## ADDENDUM NO. 1 TO PROJECT NO. 47543

### CONSTRUCTION AND ELECTRICAL WORK PROVIDE SALT STORAGE BUILDING 1 & REPLACE ROOF BUILDING 2 ROUTE 20 AND 400 WEST SENECA, NY

February 28, 2025

**1 ROOF REMOVALS PLAN**  
SCALE : 1/8" = 1'-0"

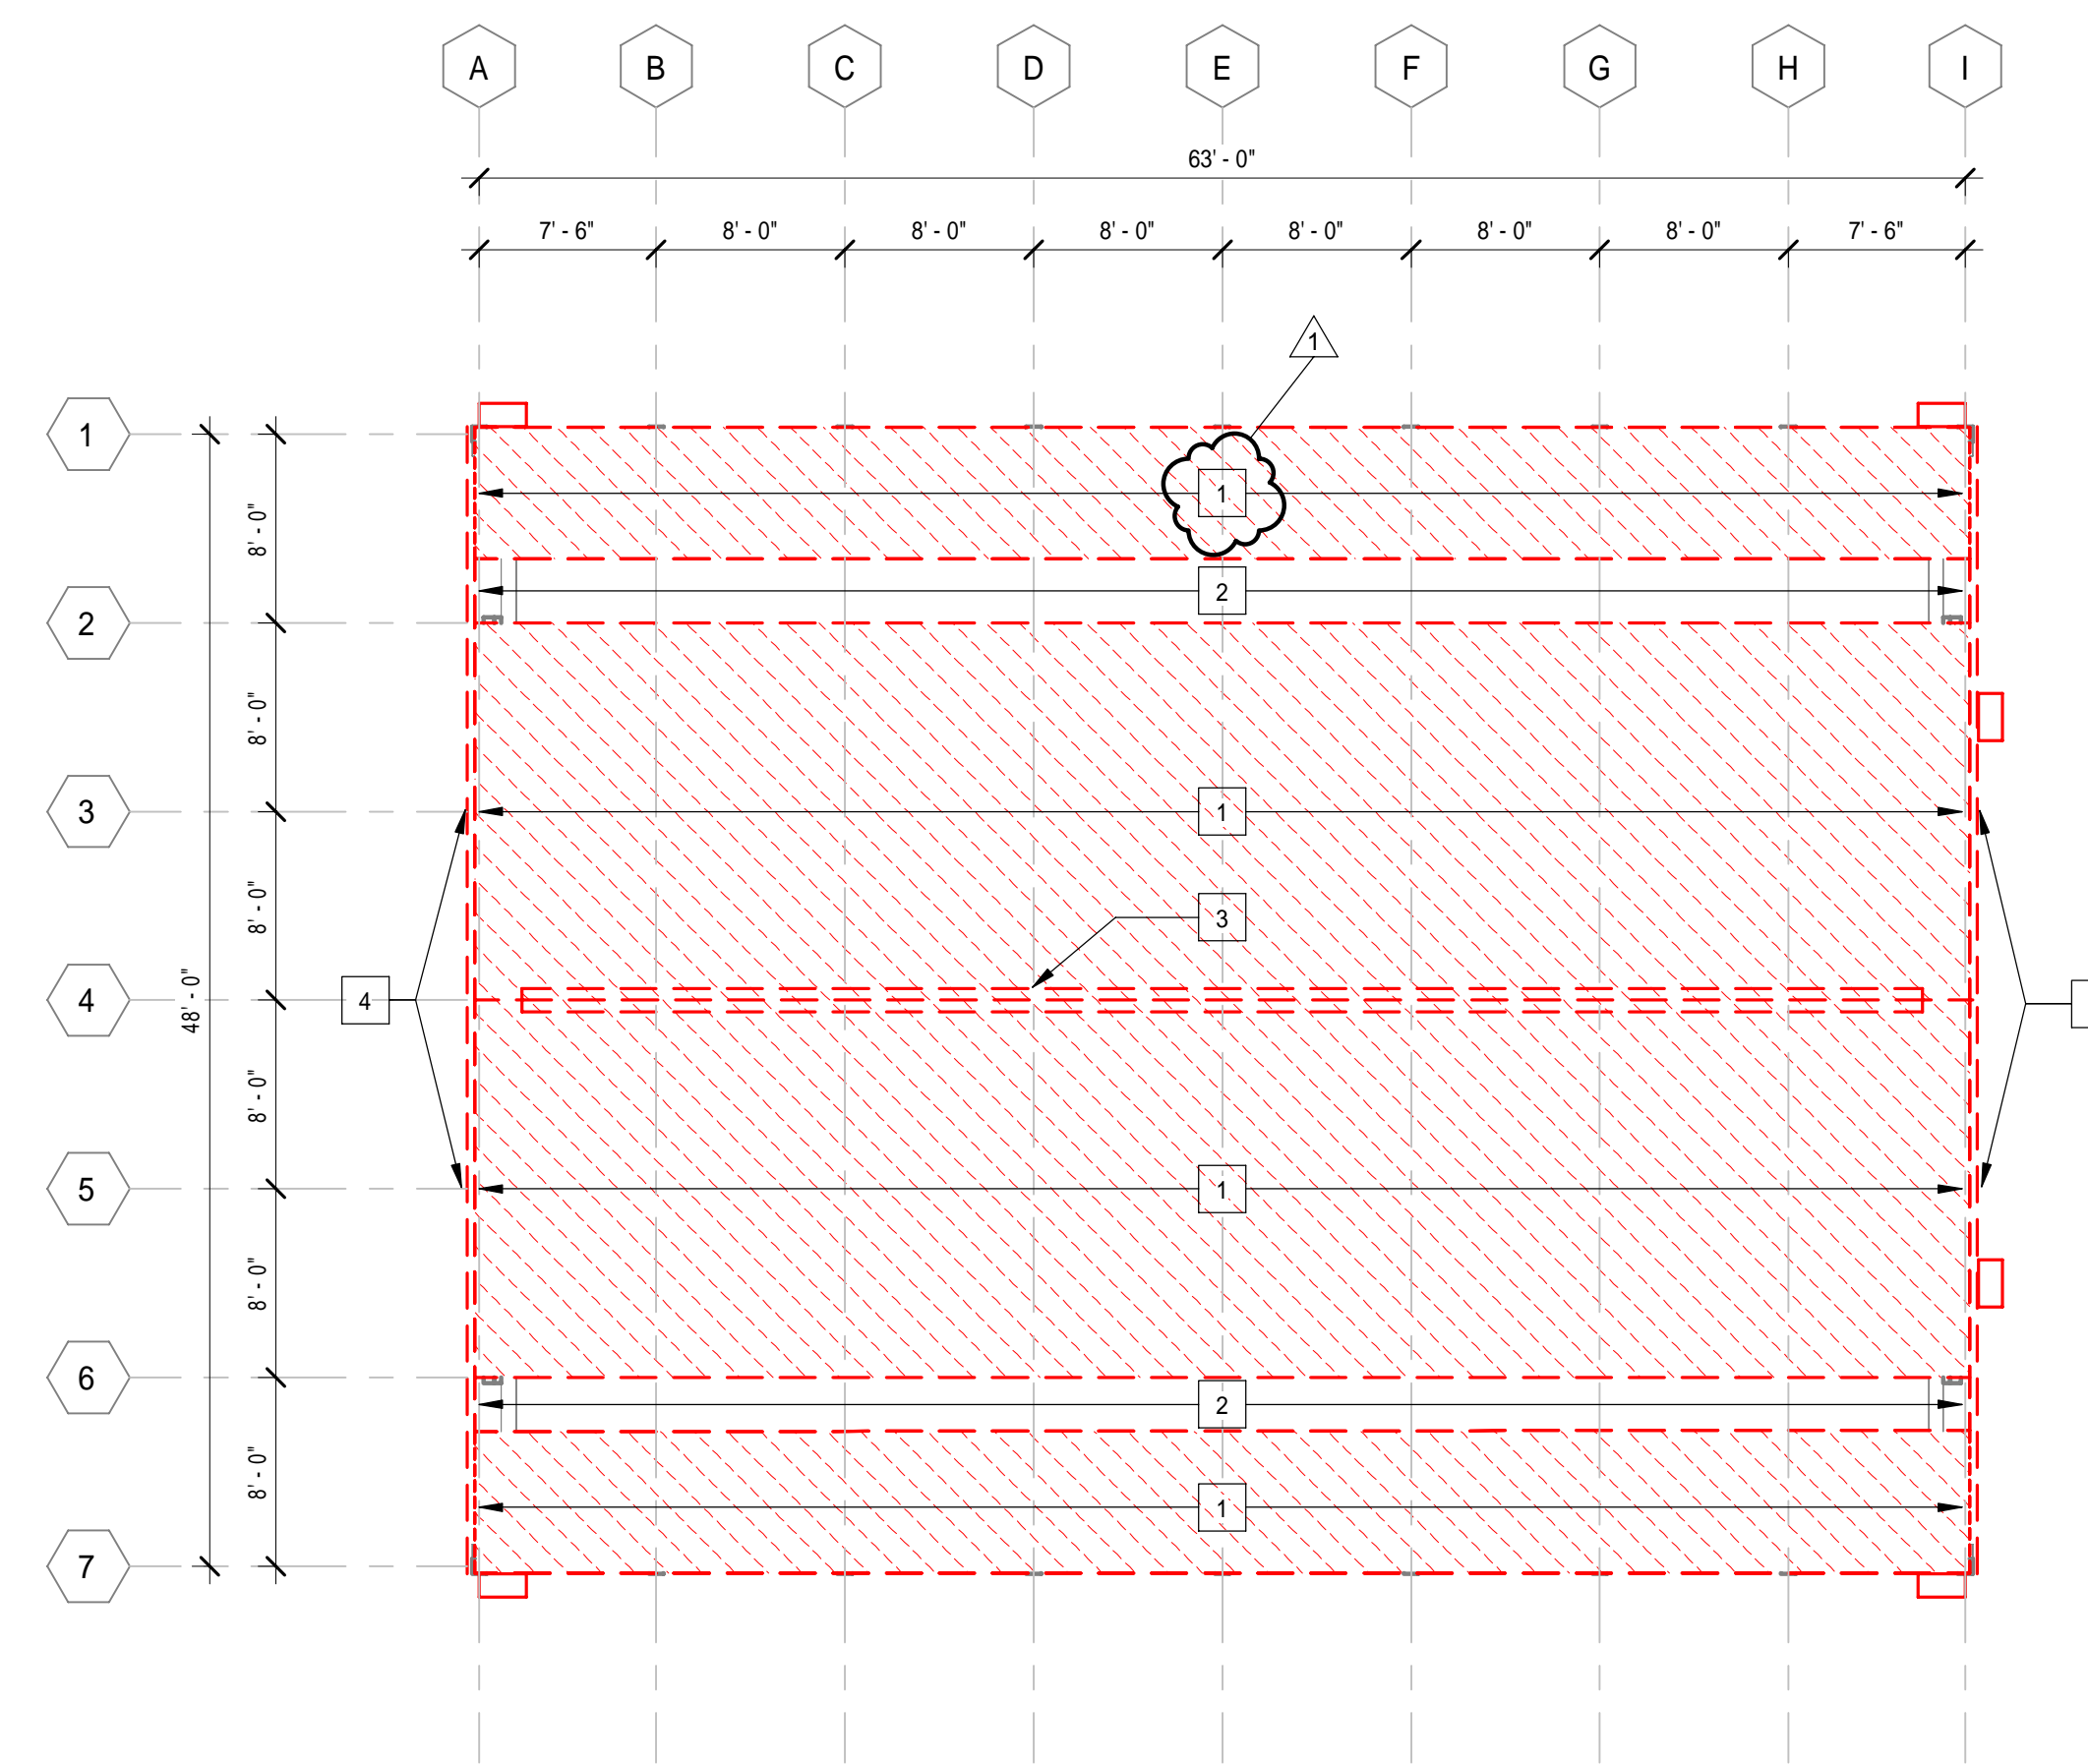
“5. Provide 200 linear feet of silt fence, location to be determined by director’s representative.”
5. Revised Drawings:
  - a. Drawing Nos. AS-101, S-102, S-201, noted “ADDENDUM #1 02/28/2025” accompany this Addendum and supersede the same numbered originally issued drawings.
